COMMONWEALTH OF VIRGINIA
COUNTY OF HENRICO

RE: POD2023-00284
Libbie Mill Midtown Condo Buildings 12-
14
POD Initial plan review

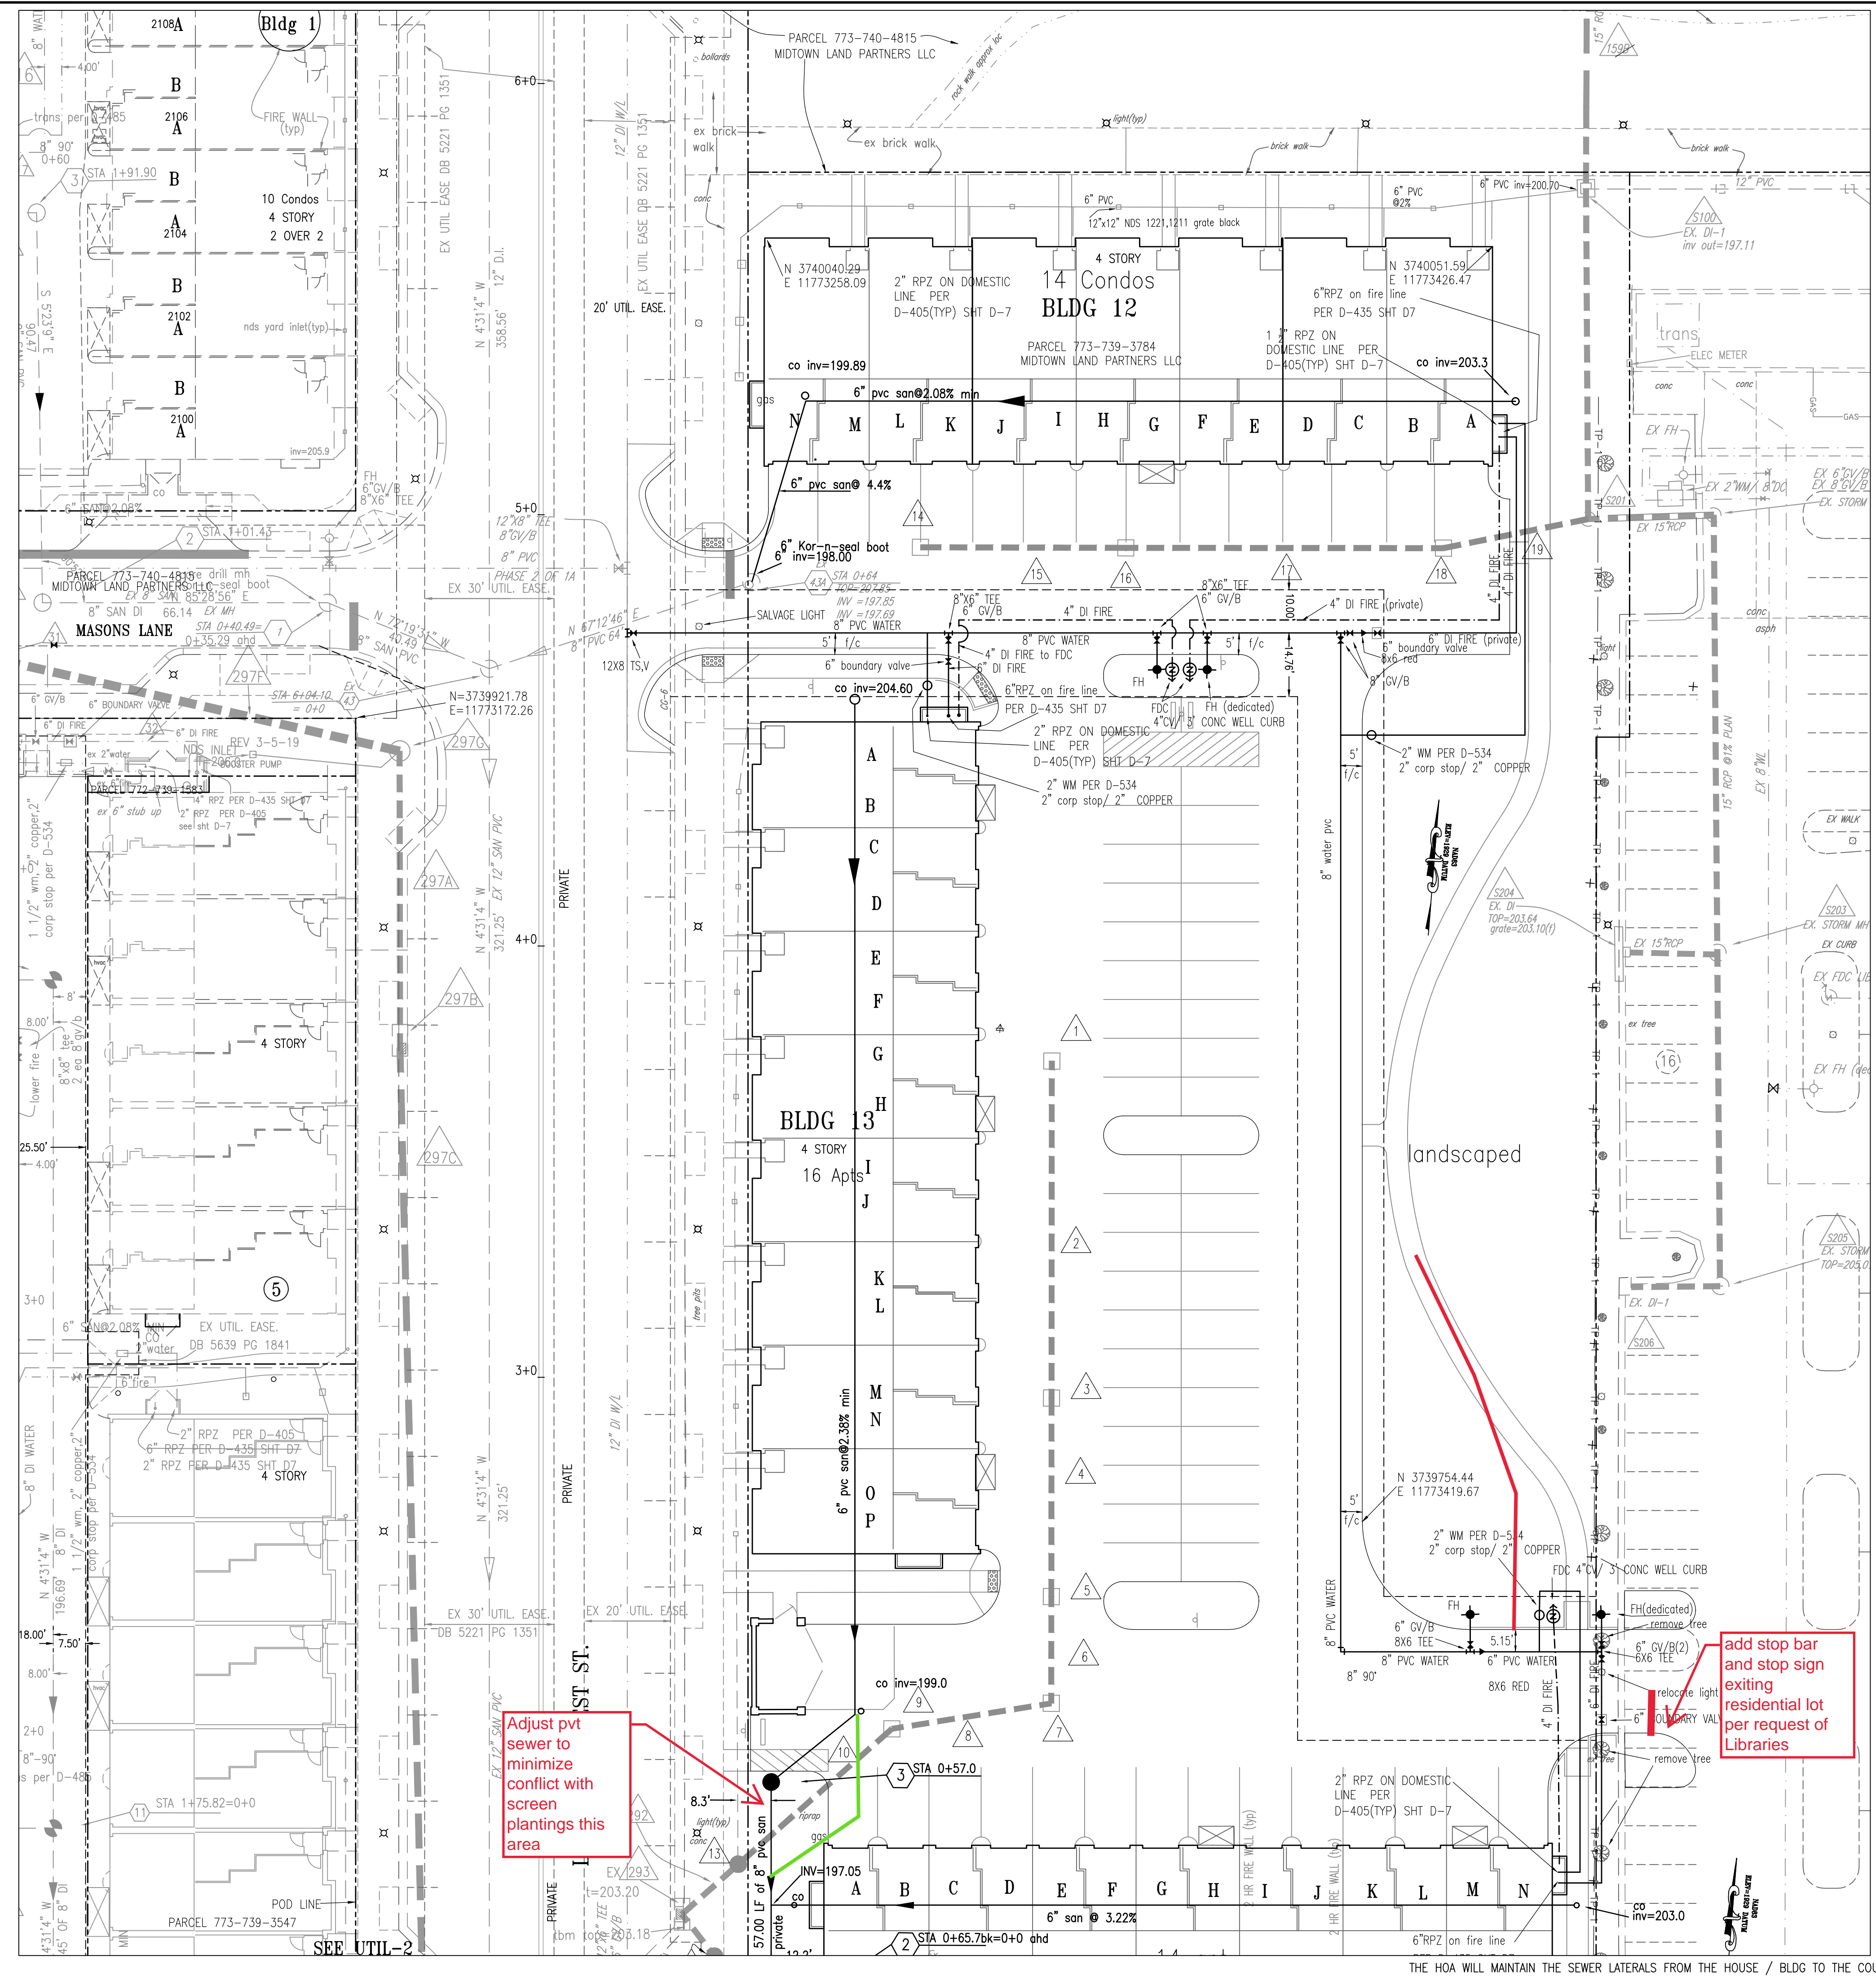
- 1) Add a stop bar and stop sign at the exit from the residential lot to the library lot as shown on the mark up plan.
- 2) Omit the sidewalk segment along the eastern edge of building 14 and revert to foundation and plant strip landscaping. Add screen wall from building corner along side of parking space as shown on the mark up plan.

- 3) Add a screen wall from the back edge of building 12 along the parking space side as shown on the mark up.
- 4) Realign the path in the green space away from the site edge as shown in the mark up.

- 10) See mark up of site plan – adjust route of private sewer to avoid the plant area adjacent to the accessible parking space northwest of building 14 at rear of building.
